## Service Bulletin

**Bulletin No:** JC-18-15

**Product Type:** Ryan Lawnaire ZTS

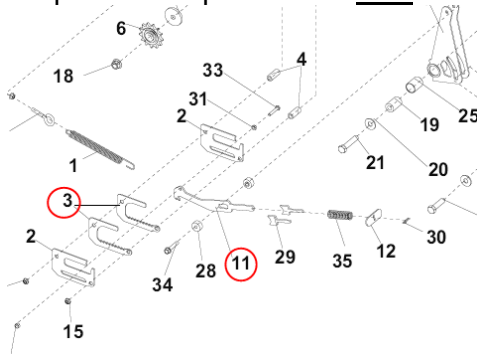
**Customer Issue:** Unintentional indexing of the tensioner mechanism could result in higher than desired chain tensions. Continued operation with higher than normal chain tension could result in premature wear of the Auto Chain Tensioner components, or cause damage or breakage to related components.

**Cause:** Auto Chain Tensioner component wear may be expedited by several factors, including component variation, operation technique, operating conditions, maintenance and cleanliness. Therefore, this is NOT a mandatory rework as not all units will encounter these conditions resulting in expedited wear.

**Action Required:** If items 4172453, plate-lock, or 4172454, arm-idler lock, (ref# 3 & 11 below) were to fail, you should not replace these components, instead, use the superseded Kit-Chain Tensioner 970622 as a replacement. This kit replaces components on both sides of the machine.
